Report to Planning Committee 10 August 2023

Report Summary			
Application Number	22/01726/FULM		
Proposal	Residential development comprising of 87 no. dwellings, including the removal of TPO trees (resubmission)		
Location	Land at Highfields School, London Road, Balderston, Newark on Trent		
Applicant	Avant Homes (Central) Ltd	Agent	DLP Planning Ltd
Web Link	22/01726/FULM Residential development comprising of 87 no. dwellings, including the removal of TPO trees (resubmission) Highfields School London Road Balderton Nottinghamshire NG24 3AL (newark-sherwooddc.gov.uk)		
Registered	13.09.2022	Target Date E.O.T Agreed	12.12.2022 11.08.2023
Recommendation	Refuse for the reason(s) set out at Section 10.0 of this report

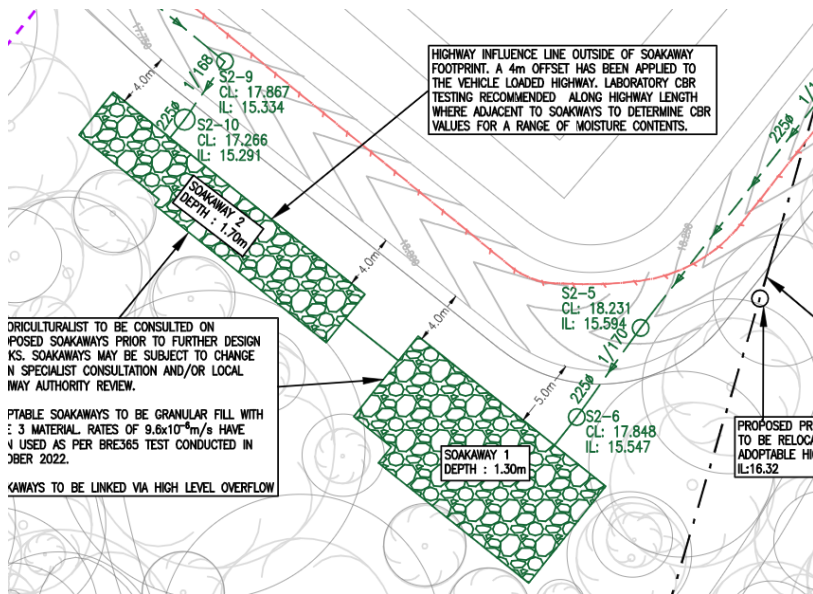
Many of the trees to be removed are to the south of the site, visible in the public realm from London Road and are specimen trees conducive to the parkland setting that the school has enjoyed. There are no new trees proposed within this area to compensate for the loss of the trees which is shown by the red shaded outlines on the plan below.

Only three new trees (shown by small dark green circles) alongside the access road would be planted to this part of the site. These trees have been depicted to show maximum canopy

spread after 25 years which nowhere near compensates for the loss of canopy spread in this area. The proposed species (Acre campestre 'street-wise') is a form of Field Maple bred for urban areas with a narrow canopy which doesn't complement the parkland setting nor are these trees of a species to achieve the stature of trees to be lost. Neither would these trees assist with succession planting.

More broadly, the planting schedule submitted shows structural planting of 89 trees. Responding to criticism, the applicant has now amended their plans to show that trees previously within the front gardens of plots to the west, are now within the area to be managed as public open space. These trees are now intended to be maintained by a management company which are set up by developers to look after all public open space elements for the lifetime of the development – usually for an annual fee (service charge) paid for by the occupiers. Whilst the trees to be planted are 'heavy standard' (between 3.5-4m tall) the species proposed are not bred to achieve high status trees and the applicant is seeking to use root barriers to limit growth in any case further compounding the position.

Many of the other 89 trees are considered to be inappropriate for their setting, being trees that are not suitable for high traffic areas. For example, trees used to break up the frontage parking to the western part of the site are Rowan or Cherry trees which are known to give birds diarrhoea. By placing the trees within the control of the management company, the concern that occupiers would be able to remove the trees is abated somewhat, albeit the trees could still be removed with the consent of the management company.

Limited details of the species of trees proposed to be planted to the eastern part of the site have been provided as plans haven't been properly annotated. However, with maintenance strips of between 1.5m and 2m wide (within the management company) and in some places being very close to the houses, it is considered unrealistic to expect trees to establish and thrive given the lack of space for growth and the species suggested.

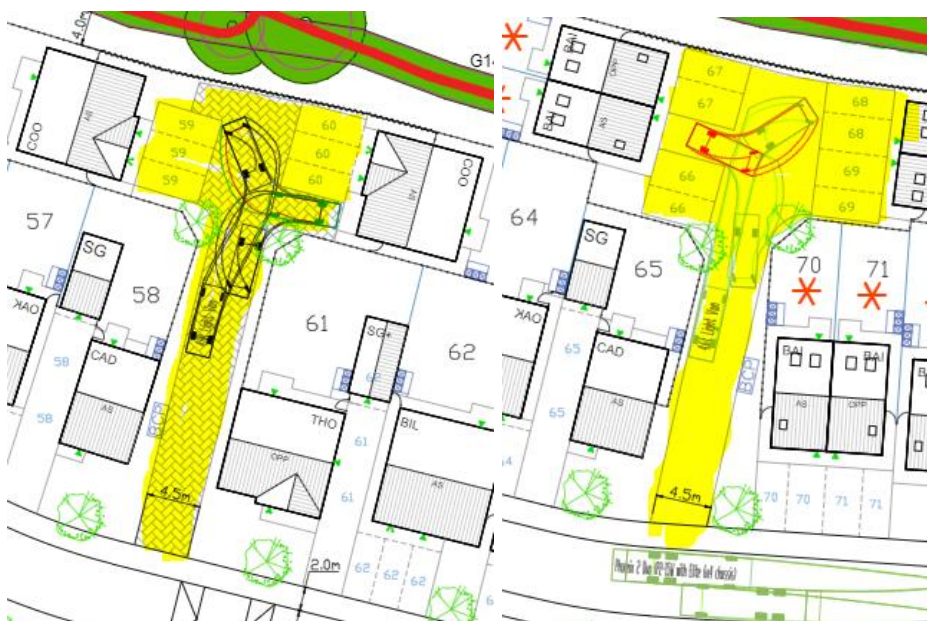
The dwellings are positioned amongst proposed 'structural landscaping' in an attempt to define and enhance streets. However as has been set out within the 'Impact on Tree' section of this report, given the lack of space provided and given the species proposed, the structural

landscaping would be unlikely to be viable in the medium to longer term and thus fails to create the tree lined streets that the NPPF envisions.

Dwellings haven't explicitly been designed to turn corners on this site as suggested by the Building for a Healthy Life guidance. On approach to the housing element of the site, receptors would first notice the foul pumping station and the sides of detached dwellings (Plot 1 and 87) which is less than ideal albeit the green space forward of Plot 52 does at least provide for a more attractive visual focus point upon entering the development. The public open space to the west of the scheme has the potential be an attractive place for residents to enjoy with houses fronting this and is a positive element of the scheme. There are however areas that are less than ideal and are missed opportunities in place making, such as the lack of an attractive visual end stop at the termination of the road/turning area between plots 22 and 27 to the west and between plots 73 and 76 to the east, which make the scheme somewhat highway led and dominated. The blue arrows on the plans below attempt to show the view that those travelling into the scheme would be faced with.

➤ *33 Glebe Park*

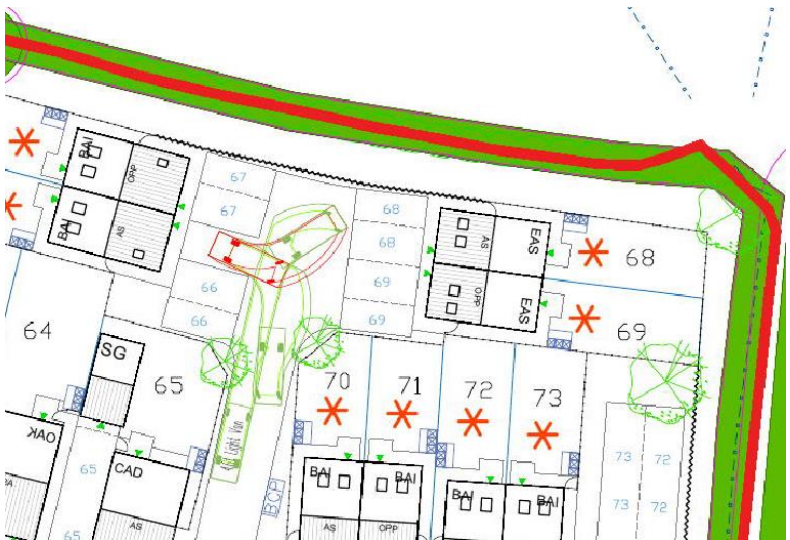
This existing property is located facing west and features a large clear glazed opening at first floor facing the application site serving what appears to be a home office/habitable room. The occupier has made representations that their patio would be overlooked by the new housing.

Plot 75 (Appleton house type) lies to the north of this dwelling also facing west with its rear garden orientated east. It is located at a distance of c10.7m (from the side of no. 33) with its side elevation blank (aside from a small obscure glazed bathroom window) thus avoiding overlooking. Its orientation avoids the loss of amenity which was a concern of the Inspector in the first appeal.

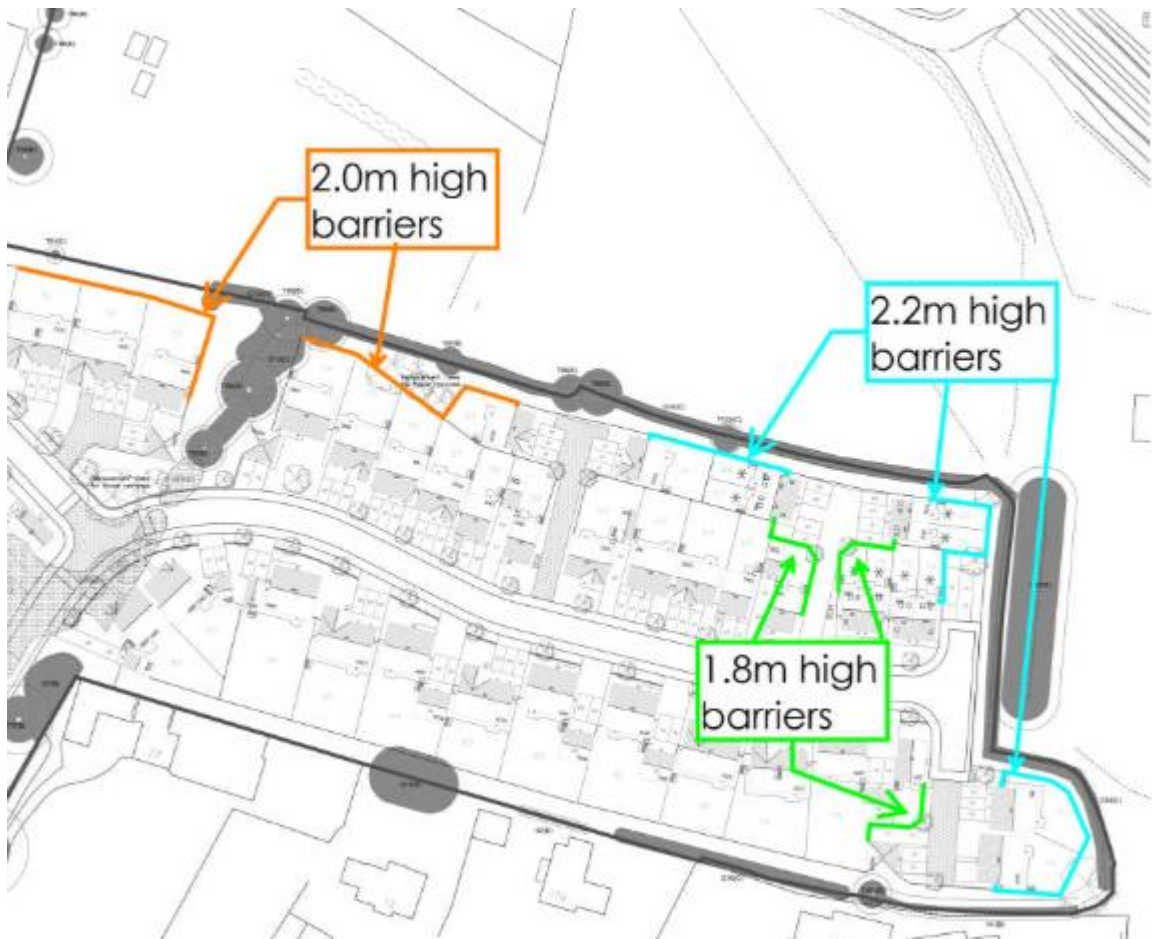
The EHO advises that the noise assessment indicates that internal and external WHO noise guidelines will be achieved with mitigation (acoustic fencing and glazing/ventilation). The commonly used assessment method relating to proposed development (BS4142) is not suitable for recreational noise, and there are no other objective assessment methods that

could be used to assist with noise impact assessment. Subjectively there is a risk of complaints about noise from residents in close proximity to MUGAs i.e. shouting, whistles, and impact noises associated with balls and other objects striking framework and panels etc. It is not clear how likely complaints would be in this case. The risk is increased given the MUGA is particularly close to the proposed residential properties, where the use is extended across a variety of activities, and operating times are likely to be extensive especially as the MUGA is intended for community use with proposed floodlighting.

Officers expect noise from the MUGA would be audible at the rear of the proposed dwellings, and the unpredictable nature of the noise is likely to be more annoying than a more predictable level of noise. While those noise levels might not be high enough to cause a significant observed adverse effect, the character of the soundscape could potentially cause small changes in resident behaviour such as closing windows, or not sitting in the garden. Acoustic fencing has been proposed to minimise noise from the MUGA. Additional noise mitigation measures could be considered including the limiting the hours of use, albeit this will affect the community benefit.

Without fully understanding the community use offer (i.e. the hours that it would be available to the community into the evening and at weekends) it is difficult to make a definitive assessment of impacts but it is considered that due to the proximity in relation to proposed dwellings there will be some compromises to the living conditions of residents.
